**MUJARRAH CANAL BRIDGE  
RAMADI, IRAQ**

**SIGIR PA-09-170  
JULY 14, 2009**

SUBJECT: Report on the Mujarrah Canal Bridge, Ramadi, Iraq  
(Project Number SIGIR PA-09-170)

**Site Photo 8. Falsework for forming concrete deck overhang**

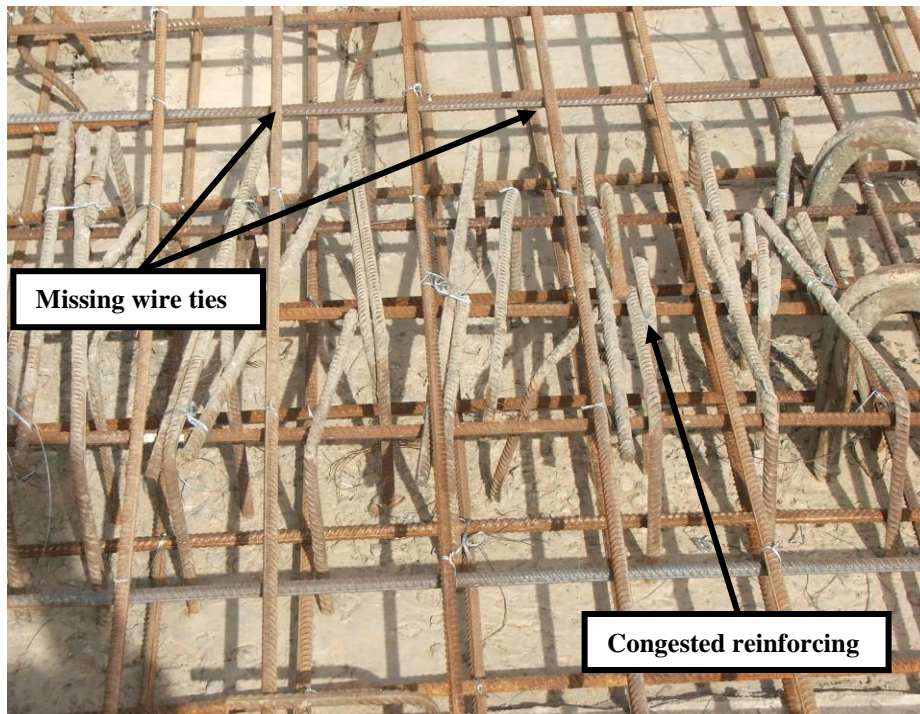
SIGIR noted several issues with the placement of the reinforcing for the concrete deck. For example, near the ends of the girders, SIGIR found areas of severe reinforcing steel congestion (Site Photo 9.) SIGIR is concerned that this configuration of reinforcing steel may prevent homogeneous concrete placement, which would result in voids in the deck. Since the purpose of the reinforcing steel in this area is to create composite action

SIGIR also noted that the bottom mat of reinforcing steel was placed directly on the precast-concrete deck pans. To provide composite action between the reinforcing and the concrete deck, adequate cover needs to be obtained around the reinforcing to permit stress transfer. Inadequate cover may result in the reduced capacity of the deck. SIGIR understands that it is a common practice for contractors to place chairs under reinforcing steel immediately before concrete placement. This helps avoid bending the chairs or rebar when walking on the matting as shown in Site Photo 7. If the contractor placed adequate chairs under the reinforcing steel prior to concrete placement, this is not an issue.

**Command Comment.** SIGIR's concern with the reinforcing steel matting placed directly on the deck pan is valid. However, it is common practice for contractors to place chairs under reinforcing steel immediately before concrete placement. This helps avoid bending the chairs or rebar when walking on the matting as shown in photograph 7. If the contractor placed adequate chairs under the reinforcing steel prior to concrete placement, this is not an issue.

**Site Photos 11 and 12. Cracking at girder ends**

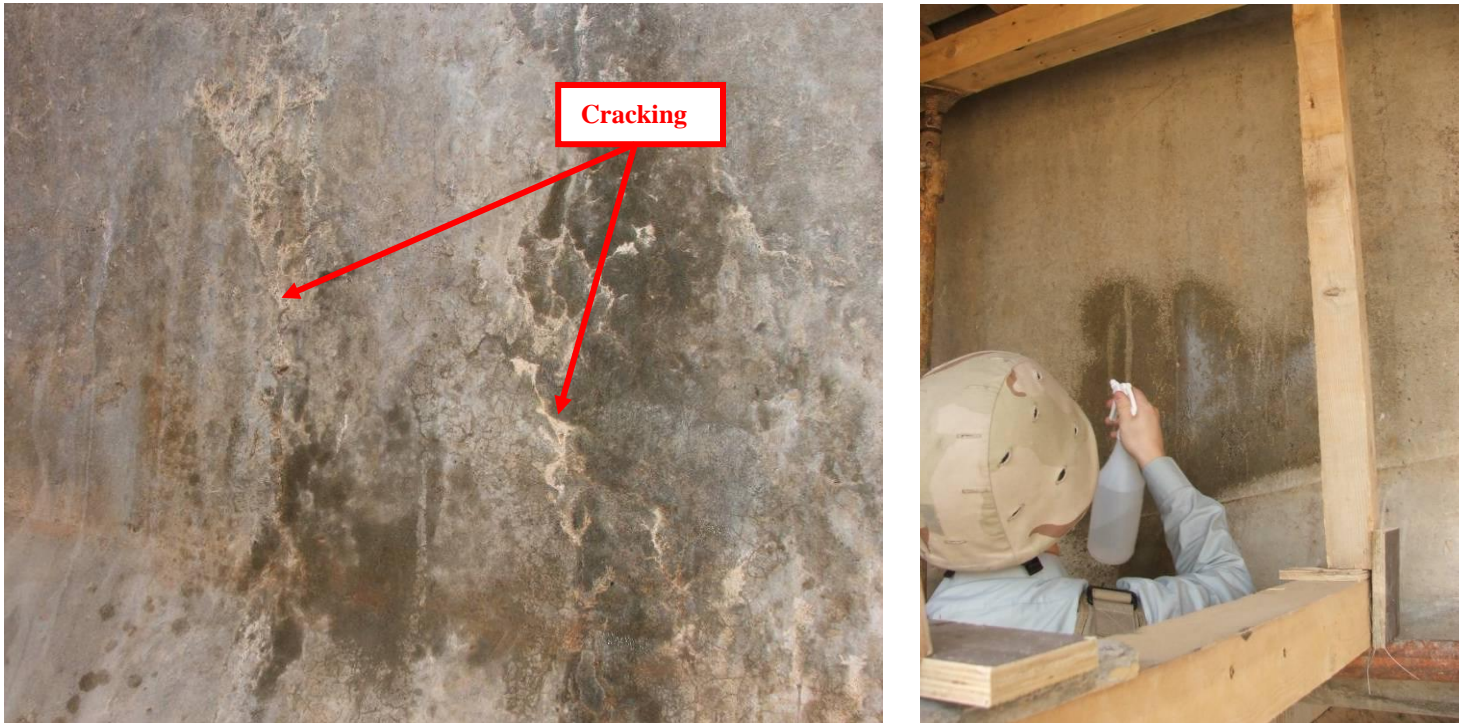
SIGIR observed no exposed honeycombing<sup>8</sup> but did identify hairline cracking on the girders. Using squirt bottles, SIGIR sprayed water onto the concrete girders to wash away dirt and make any existing cracks more visible (Photo 11 and 12). Due to time limitations, SIGIR could not map the cracking or determine if the quantity and depth of the cracks are indicators of significant issues with the beams. Any visible cracking, specifically vertical and diagonal, are indicators of potentially serious issues with either post-tensioning or shear reinforcement.<sup>9</sup> In a draft of this report, SIGIR recommended that the GRC Fallujah Resident Office further investigate and determine the seriousness

of the cracks. A Fallujah Resident Office team conducted an on-site inspection on 20 May 2009. Their inspection revealed no structural cracking, only minor surface shrinkage cracks and cracks caused by form irregularities.

On 20 May 2009, the Resident Office Officer in Charge, Project Engineer, and Quality Assurance Representative conducted an on-site visit in response to the cracks the SIGIR team reported. Their inspection revealed no structural cracking, only minor surface shrinkage cracks and cracks caused by form irregularities. The inspection team determined the crack and rough finish shown in the photos on page 15 of the report were probably caused by sand or dust accumulation in the form release agent on the girder casting. When the girder was separated from the form, the debris washed out or fell out causing the shallow voids and spider cracks shown in the photo. None of the cracks represents structural integrity issues.
